Enclosure 1
Changes to PSAR Chapters 2 and 3
(Non-Proprietary)

Figure 2.5-1: Boring Layout

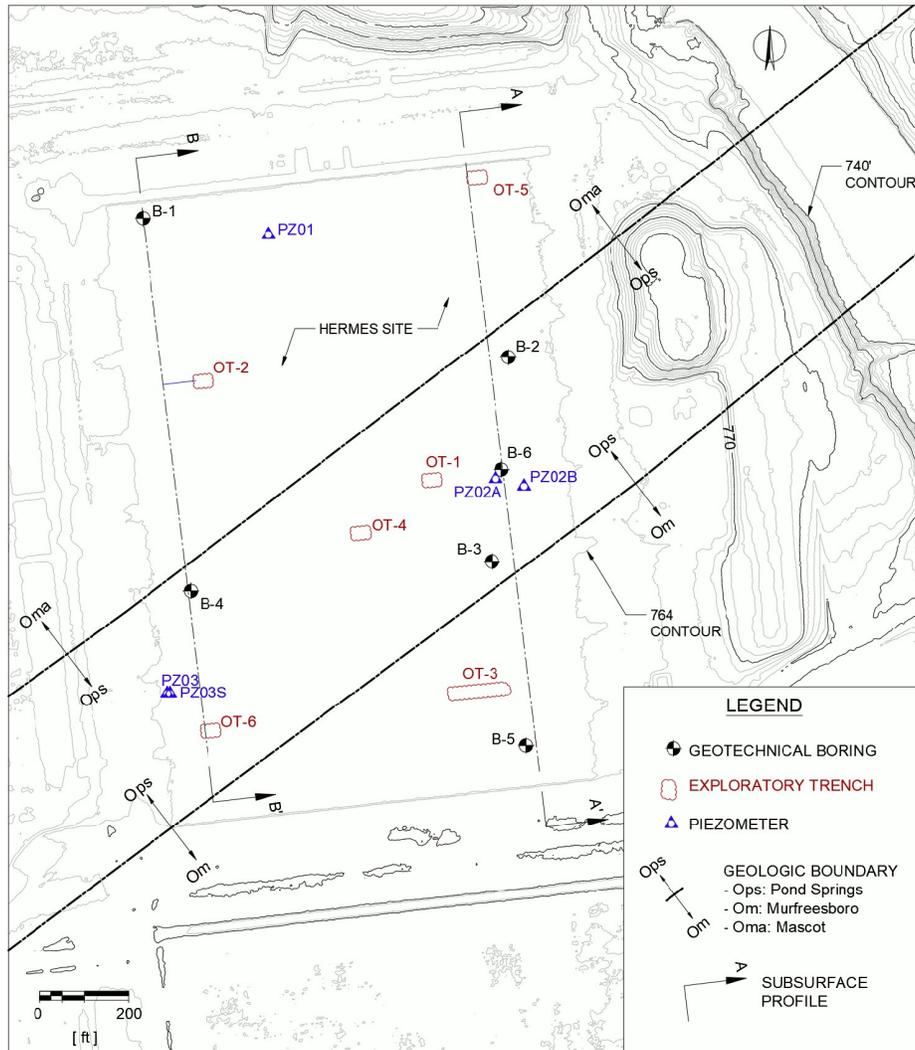
Note - Sectional Views A-A' and B-B' are provided in Figures 2.5-23 and 2.5-24.

Figure 2.5-22: Foundation Interface for Hermes

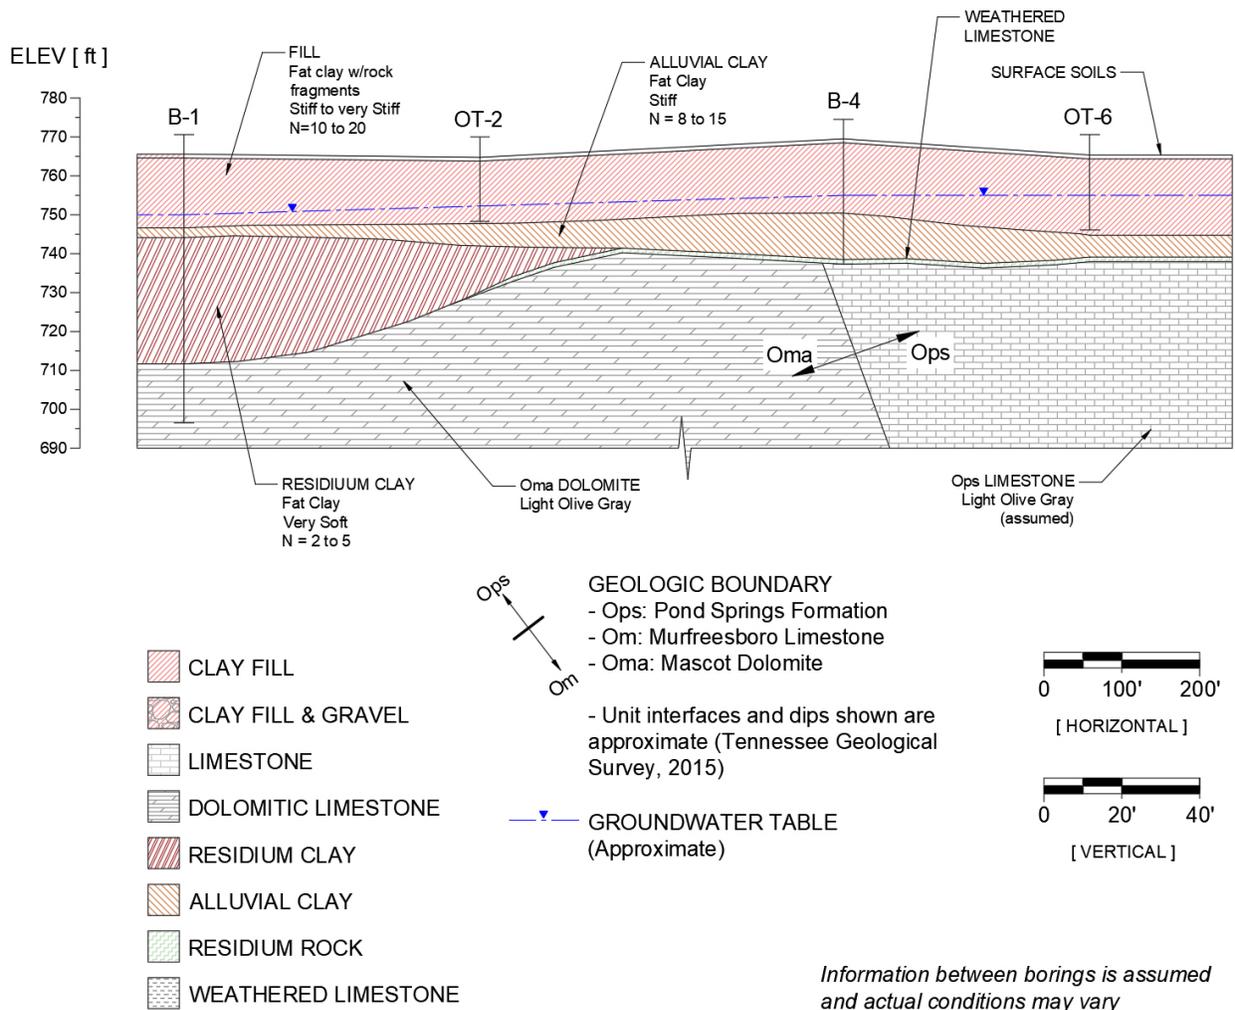
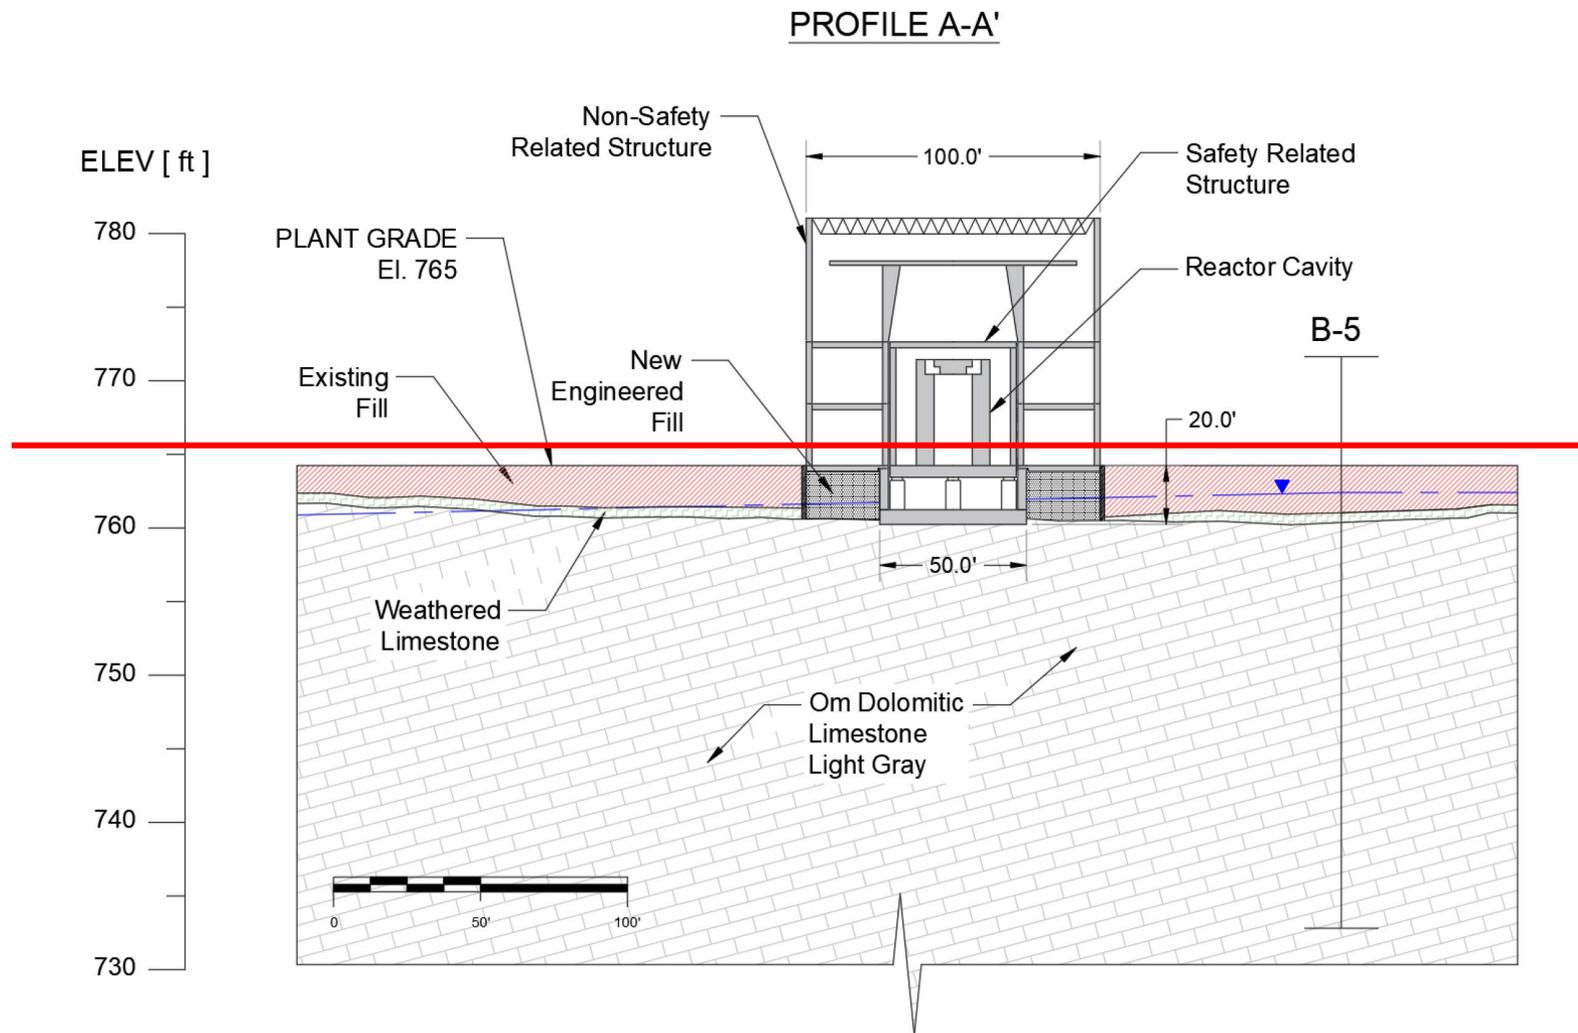
Figure 2.5-22 presents a cross section of the Hermes reactor foundation interface. The Hermes safety-related structure and the non-safety related structures do not fully share the same foundation system. The bearing system for the safety-related structure is a foundation mat resting on concrete fill over the Murfreesboro rock. Engineered fill supports the lighter portions of the surrounding non-safety related facility. Foundation and structural design aspects are described in Section 3.5. ~~The total foundation depth is 20 feet below grade.~~
